**SOIL, GEOLOGY AND
GEOLOGIC HAZARD STUDY
CLOVERLEAF DEVELOPMENT
EL PASO COUNTY, COLORADO**

April 7, 2020
Revised August 21, 2020

SITE PLAN/TEST BORING LOCATION MAP
CLOVERLEAF DEVELOPMENT
HIGBY ROAD & CLOVERLEAF ROAD
MONUMENT, CO
FOR: PT CLOVERLEAF, LLC

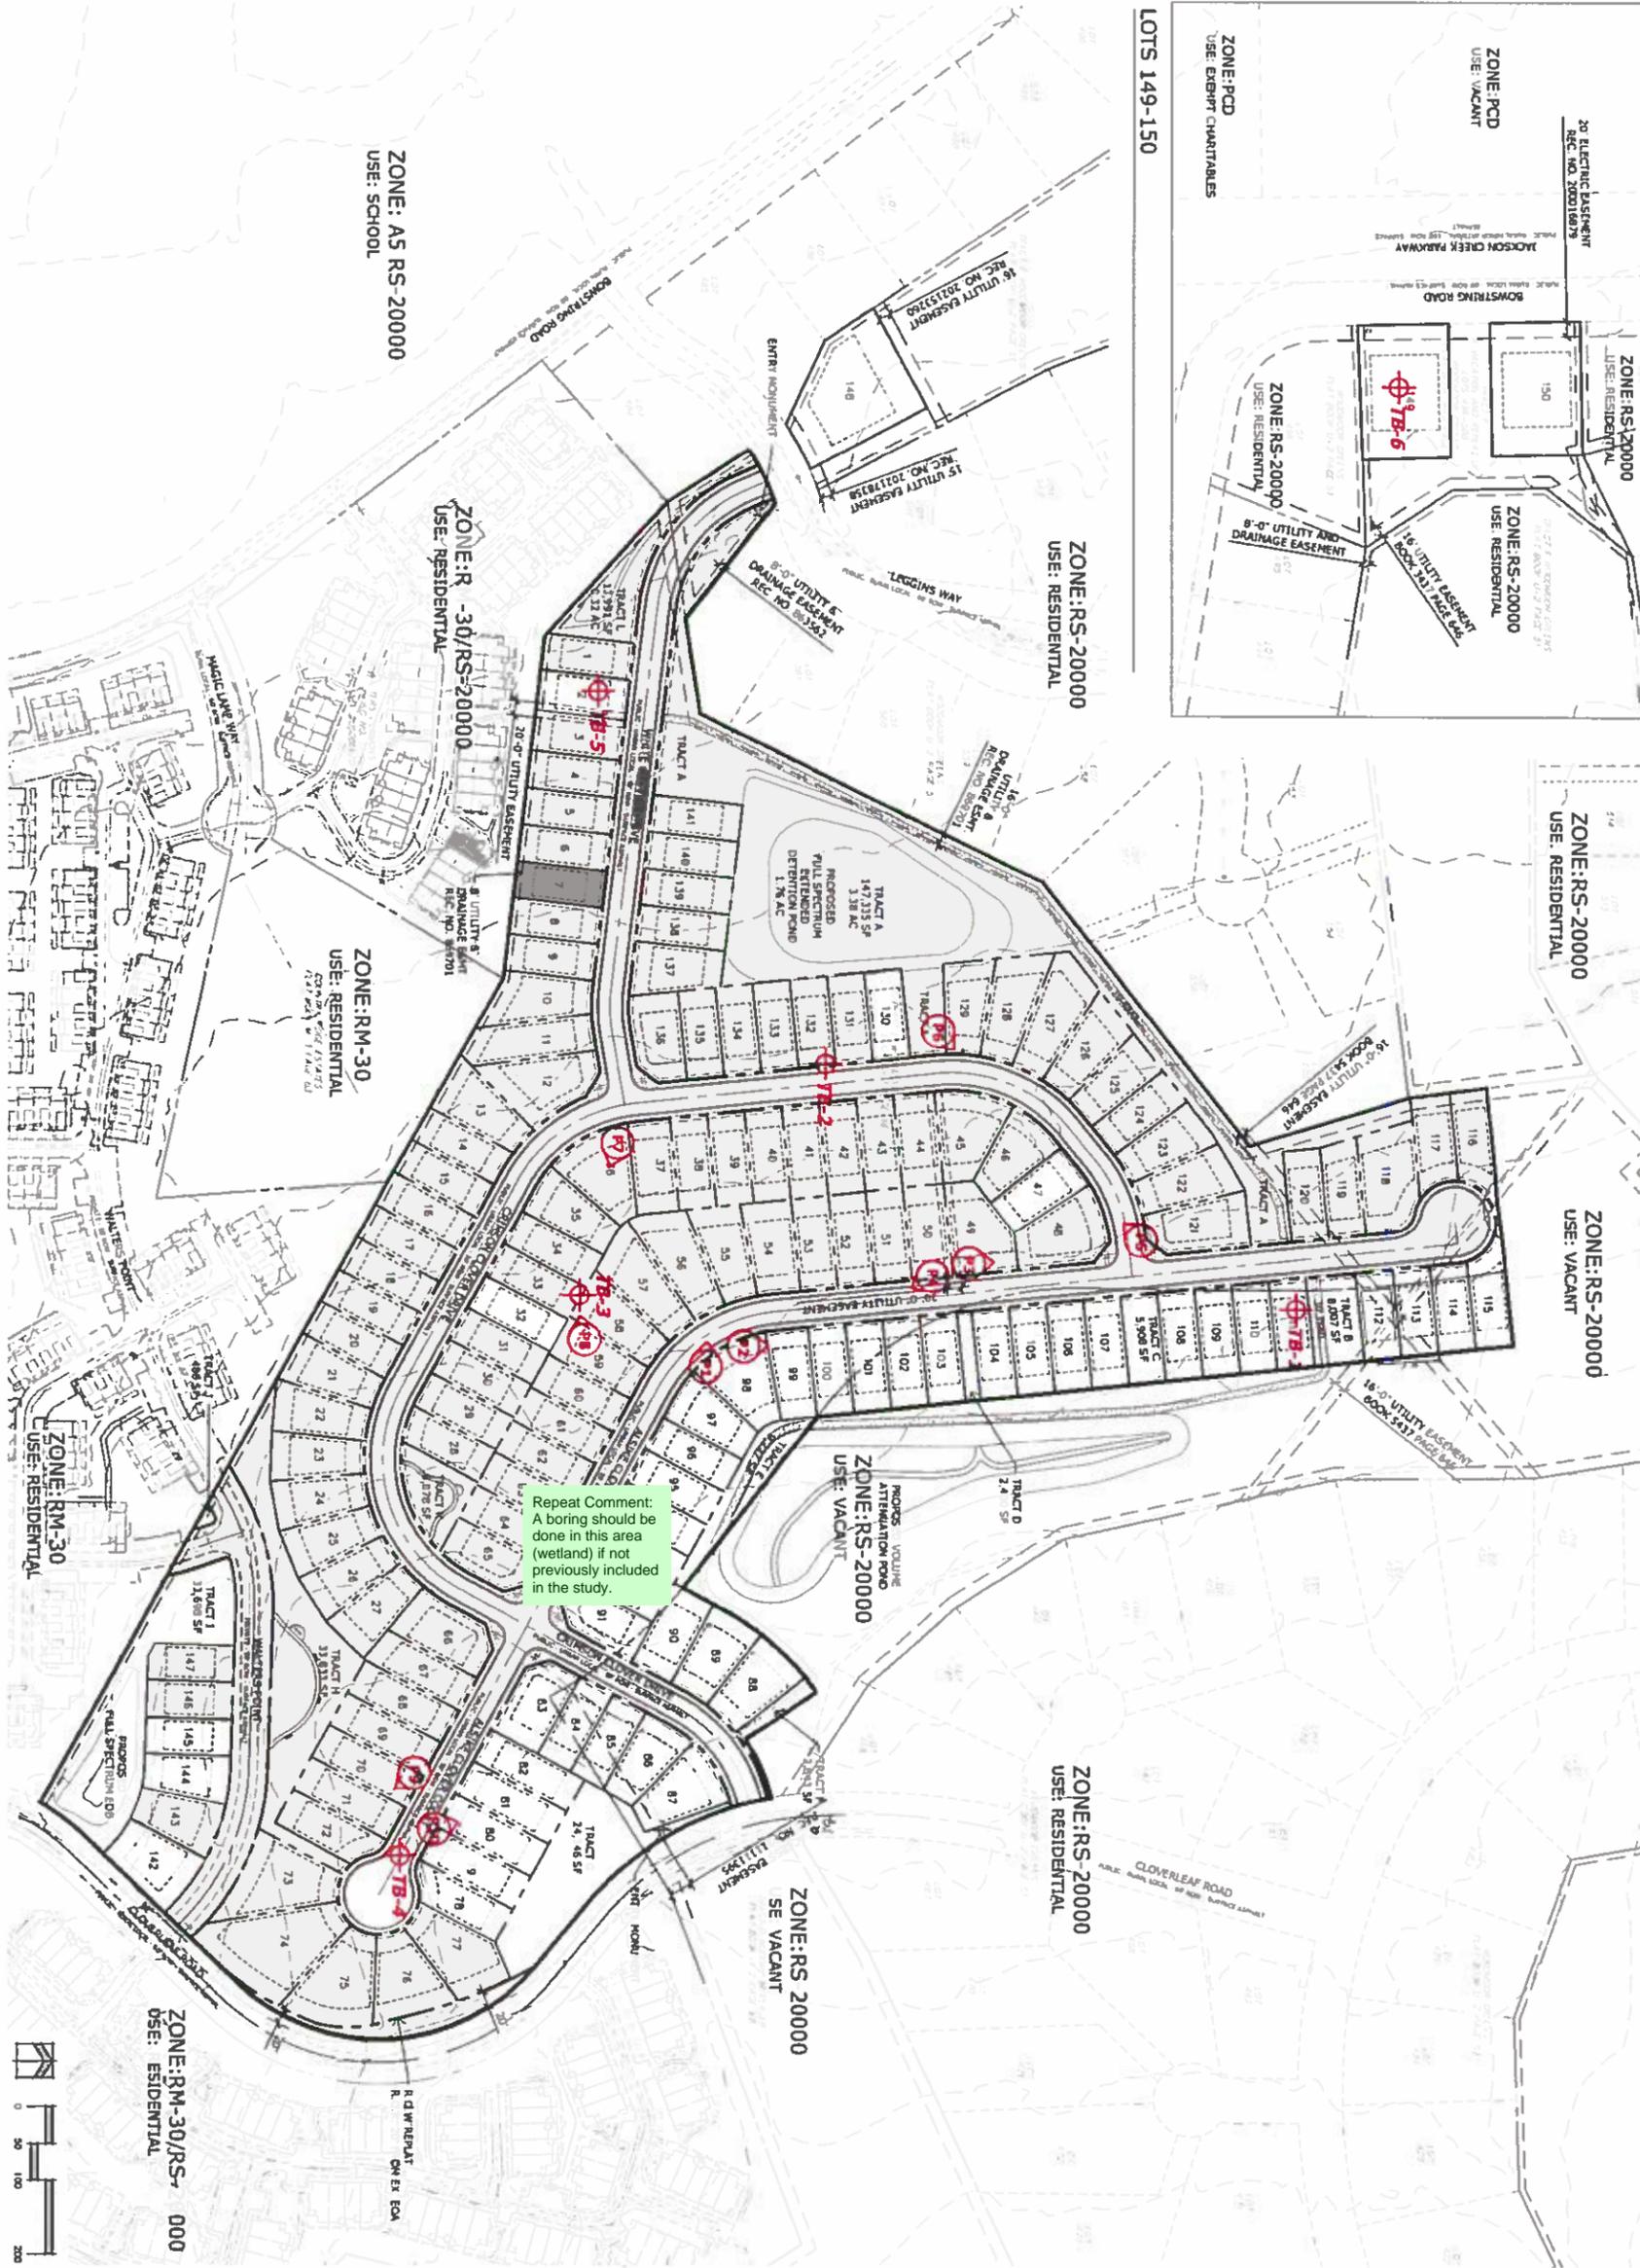
This plan seems the same as page 27 above but shows different test boring locations. The report references 6 test borings so which map is accurate?
